LACMTA: Air Compressor Suction Line Rework

Property and Top Bus Number: LA 45CLFW, 218000, 269000

Issue: The air compressor is pumping oil into the air system.

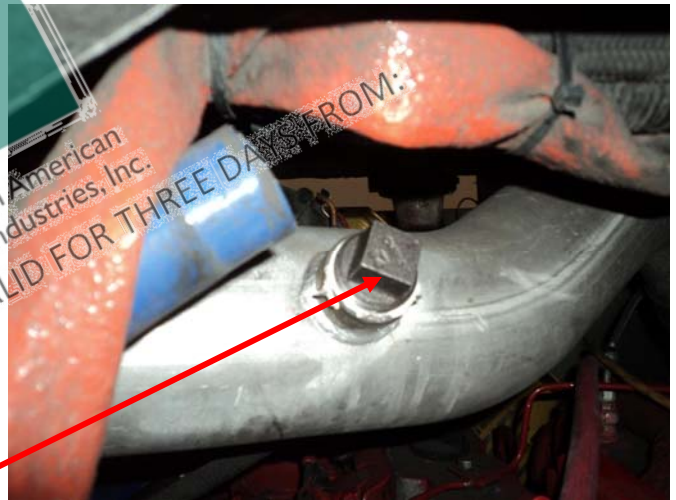
Reason/ cause: The air compressor on the earlier Metro 45 CLFW fleet is naturally aspirated. During Q1 2010, Cummins and WABCO recommended modifying LA Metro bus fleet from naturally aspirated air to boosted air from the engine turbocharger for the purpose of improving the air compressor durability.

With the naturally aspirated air plumbing, the duty cycle and air compressor head temperatures on the 45CLFW fleet were found to be relatively high in certain operating conditions. Secondary, the lack of pressure above the pistons during the suction cycle lets oil pass through the piston rings. With this condition, oil may enter into to the air system.

Solution: This work instruction will convert the engine mounted air compressor to turbo-charged (boosted) air supply to reduce the duty cycle of the air compressor and help prevent the passage of oil into the air system.

5. Remove the engine hatch underneath the rear settee seats.
6. Disconnect silicone hose at the CAC pipe. Cover the exhaust port of the CAC to prevent from contamination.
7. Cut the CAC pipe 5" from the mounting clamp with a reciprocate saw.
8. Remove the two pieces of CAC pipes.
